MILITARY SPECIFICATION SHEET

CAPACITORS, FIXED, GLASS DIELECTRIC,
(AXIAL-RADIAL WIRE-LEAD TERMINALS), ESTABLISHED RELIABILITY,
STYLE CYR22

This amendment forms a part of Military Specification Sheet MIL-C-23269/7C, dated 30 September 1970, and is approved for use by all Departments and Agencies of the Department of Defense.

FIGURE 1. Dimensions and configurations.

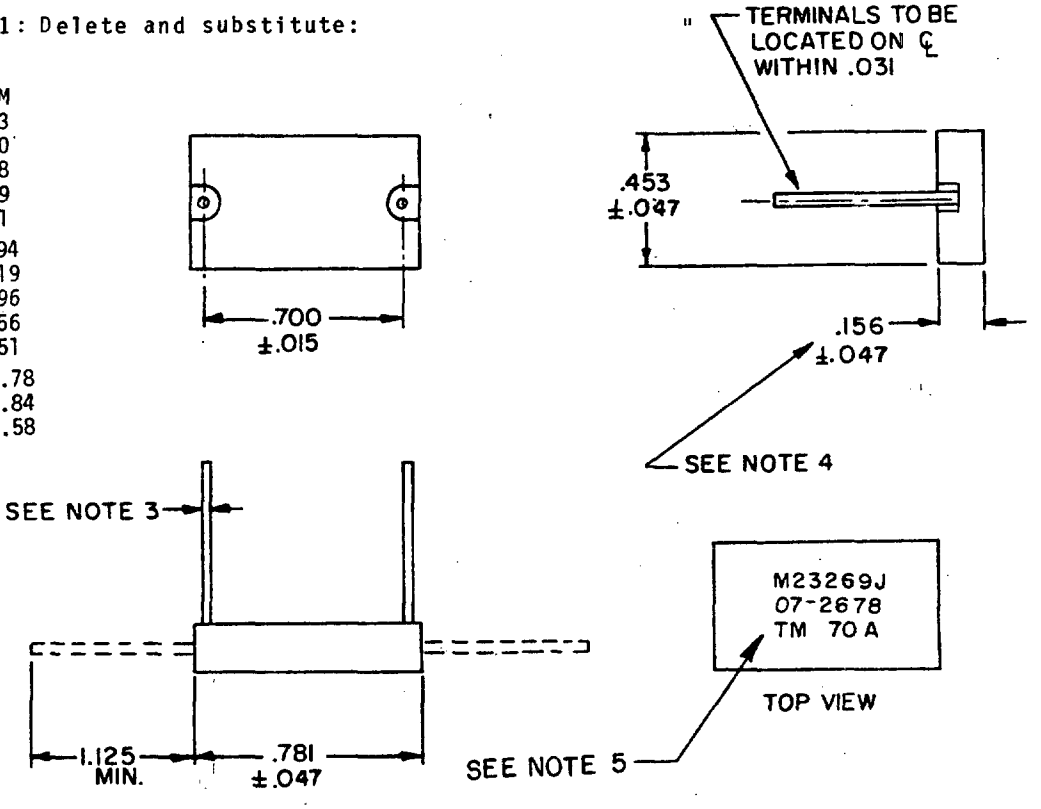
FIGURE 1: Delete and substitute:

NOTES:
1. Dimensions are in inches.
2. Metric equivalents are given for general information only and are based upon 1 inch = 25.4 mm.
3. The lead diameter shall be .032 +.004, -.001 for capacitance values below 1800 pF, and .037 +.004, -.001 for capacitance values above 1600 pF.
4. For any value above 1600 pF this dimension shall be .219 ±.047.
5. See marking requirement.
